Response Letter to the Referees

Referee #2:

In this manuscript, Wang et al. produced a database entitled China-LDRL, which contains (1) thousands of detected large (>1 km²) permanent water bodies (excluding free-flowing rivers) in China, (2) an explicit separation of reservoirs from natural lakes among these large water bodies, and (3) the dam points associated with the large reservoirs, with a distinction between river dams and reservoir dams. This is yet another useful data tool in the proliferating global and regional water body datasets.

Fig. S2. Georeferenced coordinate offsets of dams from the GeoDAR within high-resolution images.

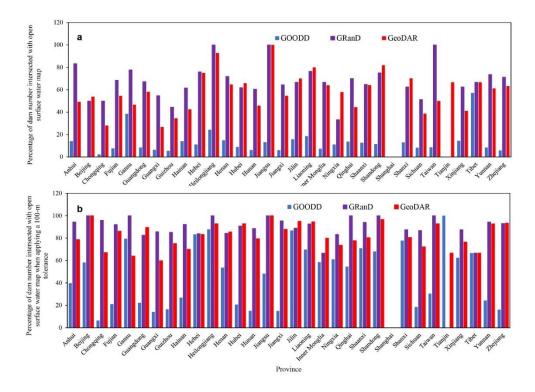
4) In addition, the GeoDAR dataset the authors used seems to be an older version. The newest and fully peer-reviewed version of GeoDAR is available at https://doi.org/10.5281/zenodo.6163413 (accepted paper in press). The authors of GeDAR have manually reduced the geographic offsets of many dams in China, so I recommend the authors re-performing the comparison with GeoDAR using its newest version.

Reply: We downloaded the newest version of GeoDAR, and checked the dam locations. We found that this newest version had much better accuracy than the previous version although some dams also have offsets due to the GPS shift in China (**Fig. S2**). In addition, we further overlapped the newest GeoDAR layer with our yearlong SWB map, and we found $58.49 \pm 6.07\%$ of its dams were intersected with the yearlong SWB layer, and $82.33 \pm 3.98\%$ and $90.22 \pm 3.18\%$ intersected when the tolerance was 100-m and 500-m (**Fig. S10**). In the revised main text, we reperformed the comparison between our results and newest GeoDAR and discussed the potential reasons for the differences (Line 368-395).
